Service Bulletin 517
Issue 1 - August 2014

| Subject: Indicator Stem Incorrectly Installed | | | | |
| 517 | Tiger Explorer ABS | From | 627380 | Brazil Market only |

1. Front direction indicator (long stem)
2. Rear direction indicator (short stem)

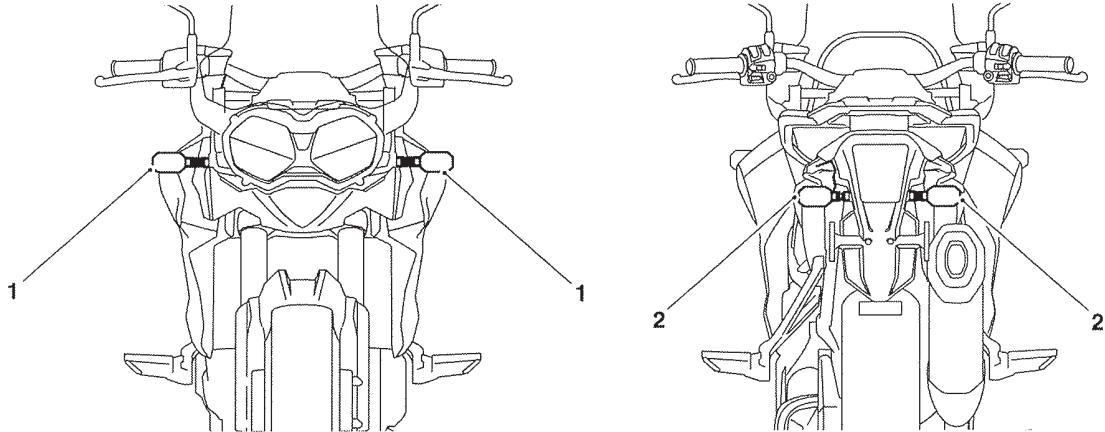
1. Check the direction indicators for correct fitment, as shown below.

- Ensure each direction indicator is positioned with the drain hole facing downwards.

1. If the direction indicators are not installed correctly, reposition to the correct location.

Front Direction Indicators

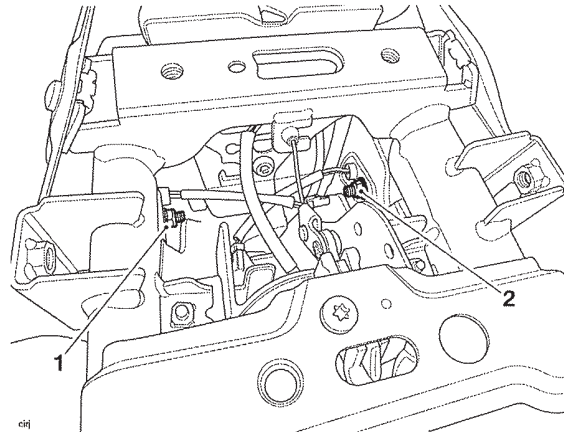
1. Remove the seat, as described in the Service Manual.
2. Disconnect the battery, negative (black) lead first.
3. Undo and remove the short stem (rear) direction indicator(s) if fitted, as described in the Service Manual.

- Lock nuts can be reused, providing resistance can be felt when the locking portion passes over the thread of the bolt or stud.
 - Always use the correct replacement lock nut as recommended in the Triumph Genuine Parts catalogue.
4. Fit the long stem (front) direction indicator(s) and tighten the fixings to **5 Nm**, as described in the Service Manual.
 5. Reconnect the battery, positive (red) lead first and tighten the battery terminals to **4.5 Nm**.
 6. Refit the seat, as described in the Service Manual.
